DRAINAGE AND TRANSPORTATION INFORMATION SHEET

**RE: Revised Grading Plan (G16-D095E)
National Electric
Albuquerque, New Mexico**

ENGINEER'S SEAL	NATIONAL ELECTRIC	DRAWN BY WCWJ
DAVID SOULE NEW MEXICO 14522 REGISTERED PROFESSIONAL ENGINEER	GRADING AND DRAINAGE PLAN	DATE 7-20-15
8/1/15	Rio Grande Engineering 1806 CENTRAL AVENUE SE SUITE 201 ALBUQUERQUE, NM 87106 (505) 872-0999	21514-LAYOUT-4-29-15
DAVID SOULE P.E. #14522		SHEET #
		JOB # 21514

ENGINEER'S SEAL	NATIONAL ELECTRIC	DRAWN BY WCWJ
		DATE 7-20-15
8/1/15		21514-LAYOUT-4-29-15
DAVID SOULE P.E. #14522	 <i>Rio Grande Engineering</i> 1806 CENTRAL AVENUE SE SUITE 201 ALBUQUERQUE, NM 87106 (505) 872-0999	SHEET # —
		JOB # 21514

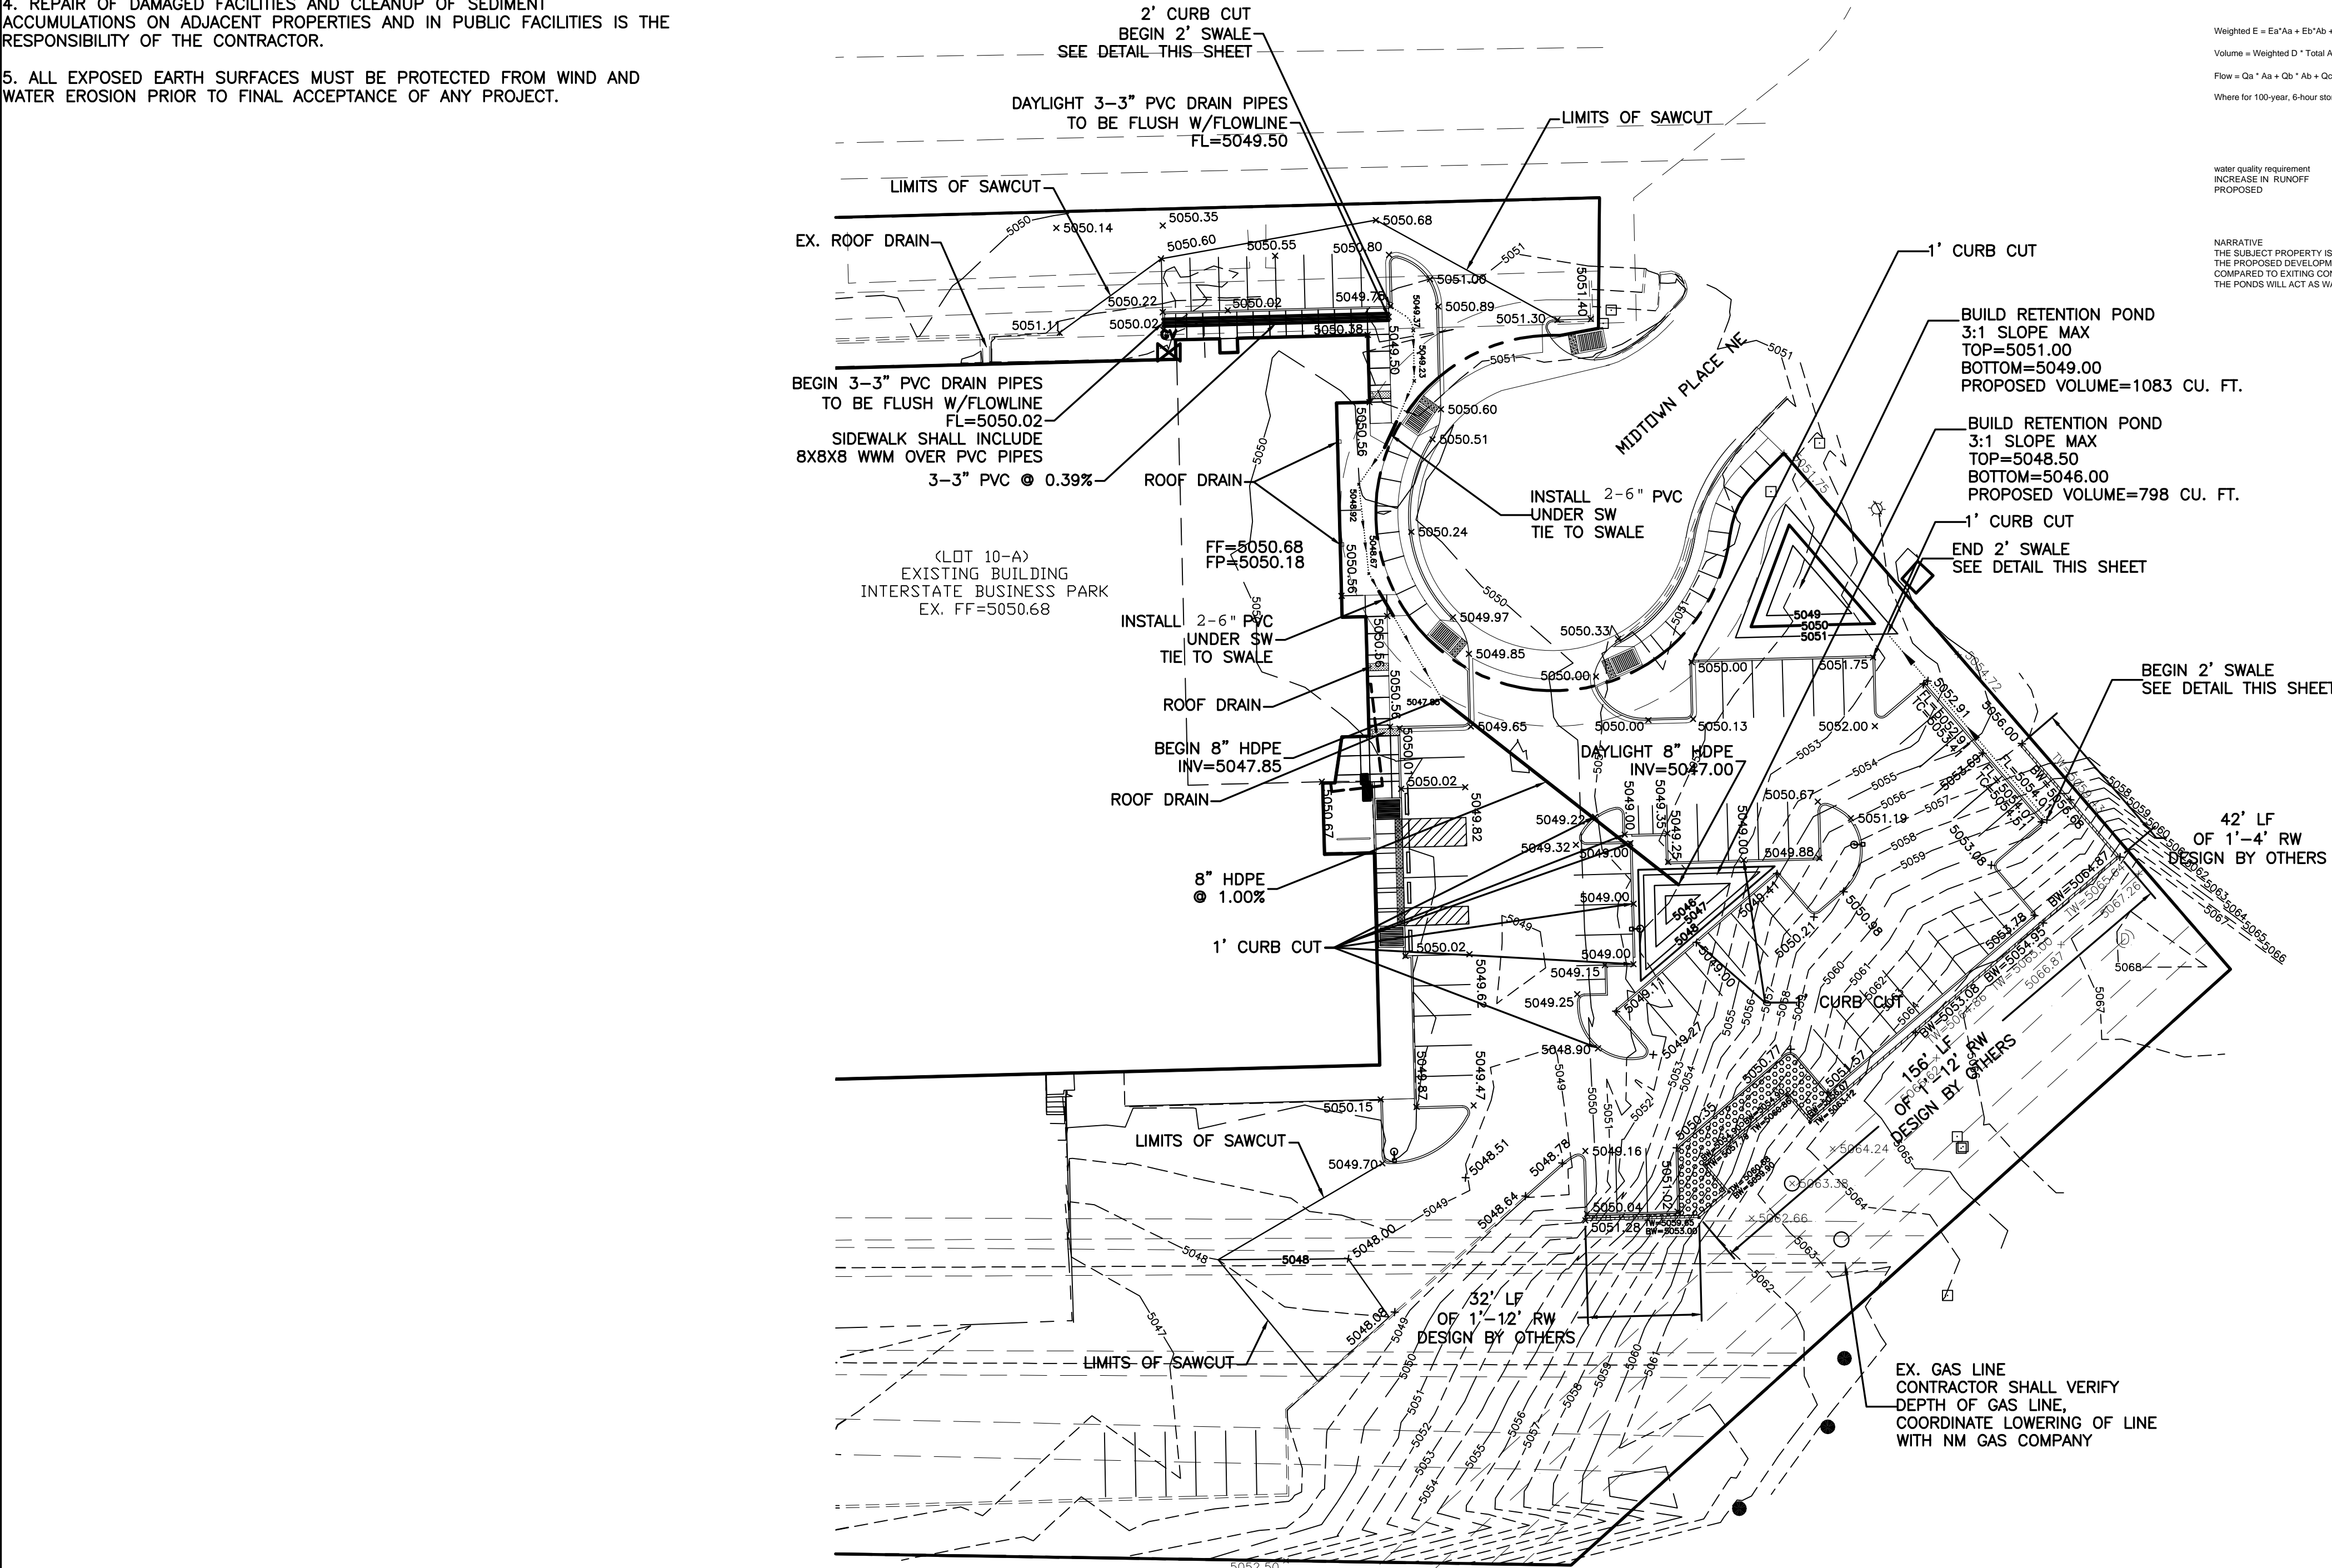
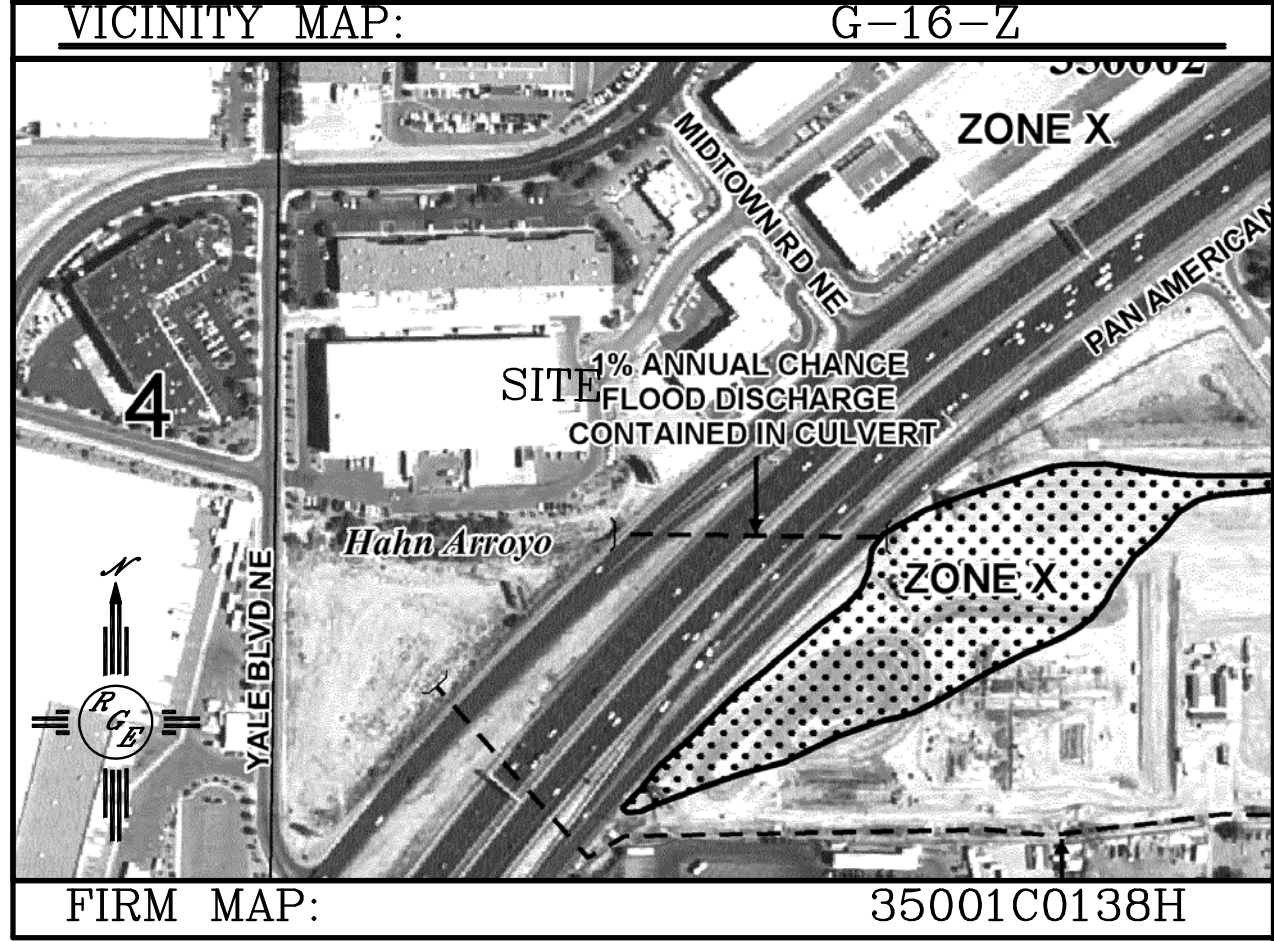
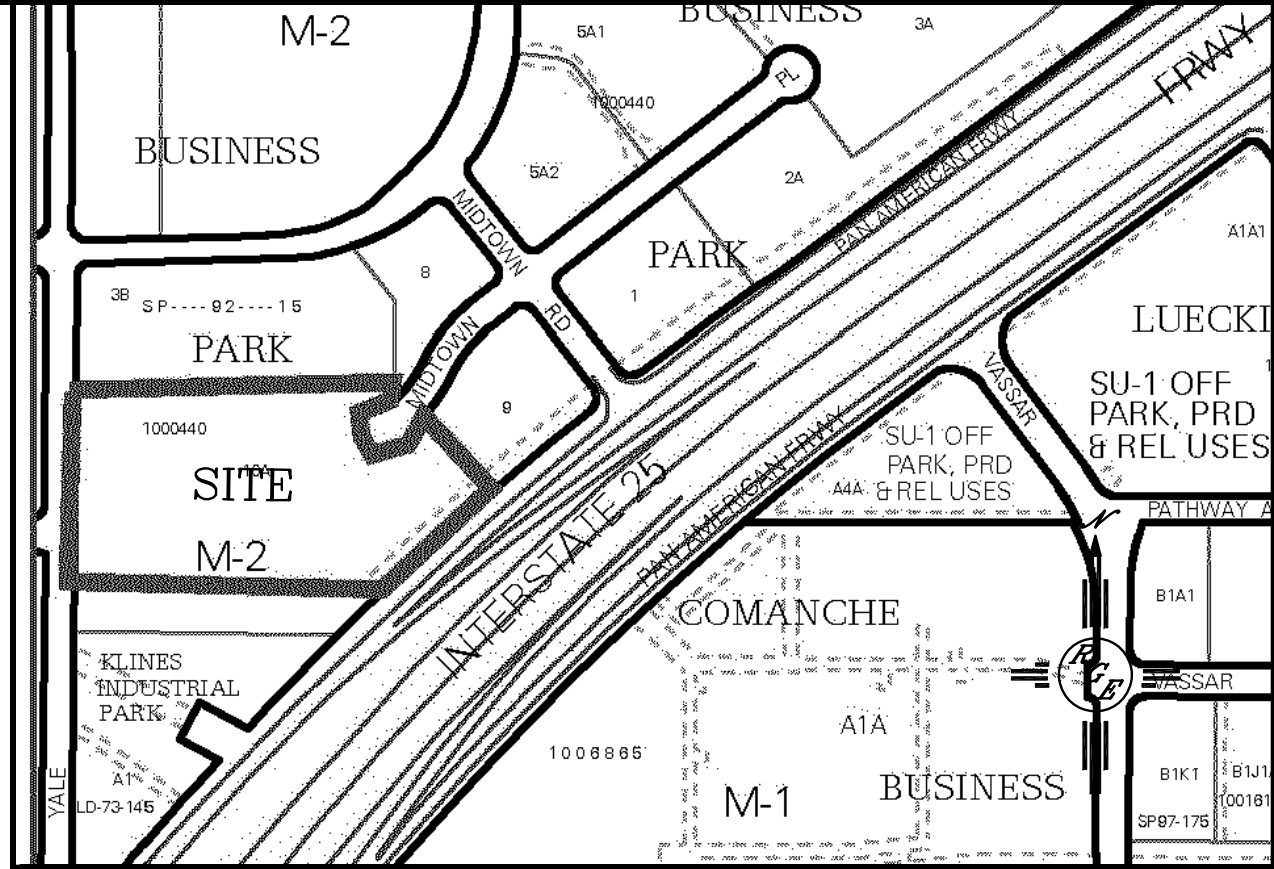
The purpose of this letter is to accompany the enclosed revised grading plan. The plan has been revised to address your written comments dated May 28, 2015. The following is an answer to the corresponding comment number to your letter.

1. We have provided a basin map and labeled project limits
2. We have labeled the pond contours
3. We have shown a swap form the 5049.85 at entry to the pond on north side of site.
4. We have shown the roof drains
5. We have updated the drainage narrative to discuss upland flows and retention volumes.
6. We have labeled the flows in the pips and included calculations for capacity in the
